# STCP Amendment Proposal Form

PA012

STCP 18-3 – Incorporation of Outstanding Change Requests

**Attachment 2: Revised Legal Text for STCP 18-3 TEC Changes**

DGDP 18-3 TEC Changes\_draft 1 pg 2 TEC Decrease Process / Change To Application Process Timescale

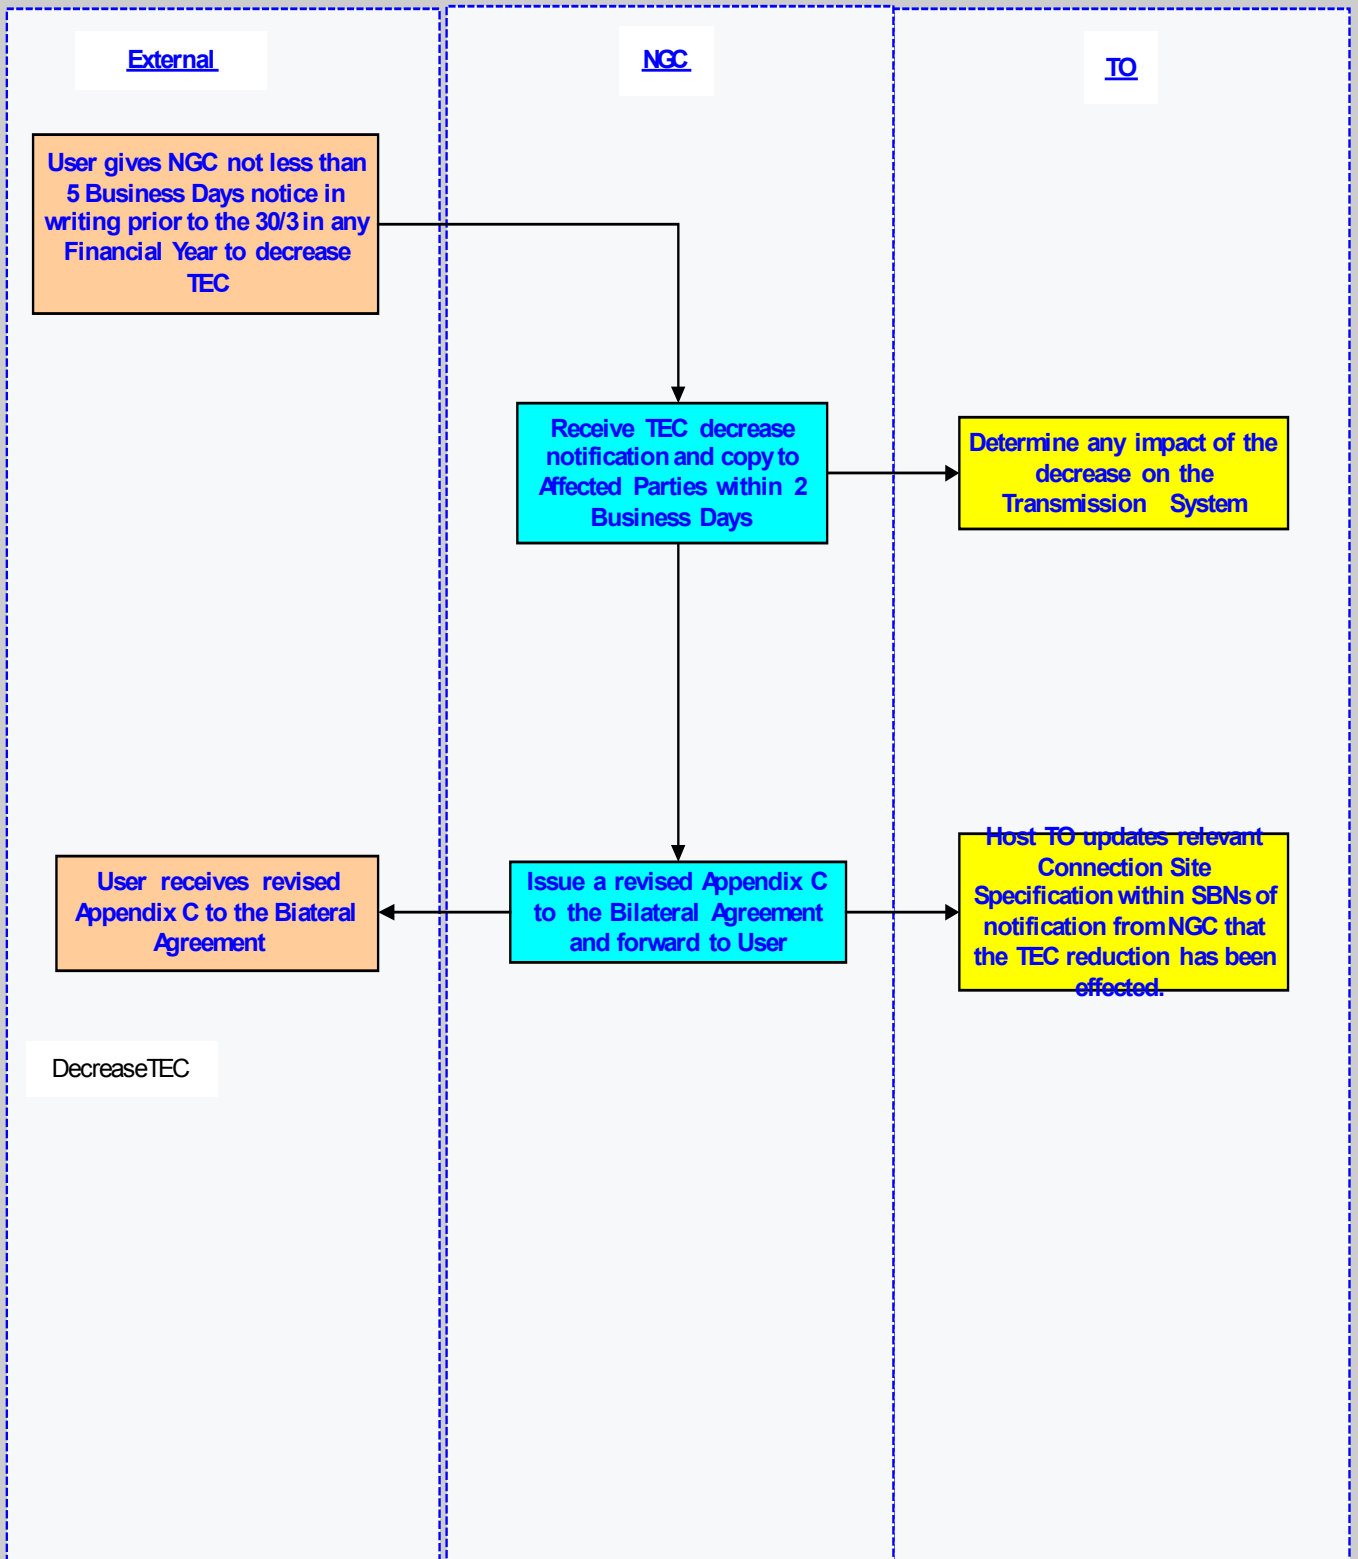
The following text has also been inserted before each of the Flow Diagrams within the STCPs clarifying that the text of the STCP has precedence in the event there is any disparity between the text and the flow diagrams:

“Note that the Process Diagrams shown in this Appendix [B] are for information only. In the event of any contradiction between the process represented in this Appendix and the process described elsewhere in this STCP, then the text elsewhere in this STCP shall prevail.”
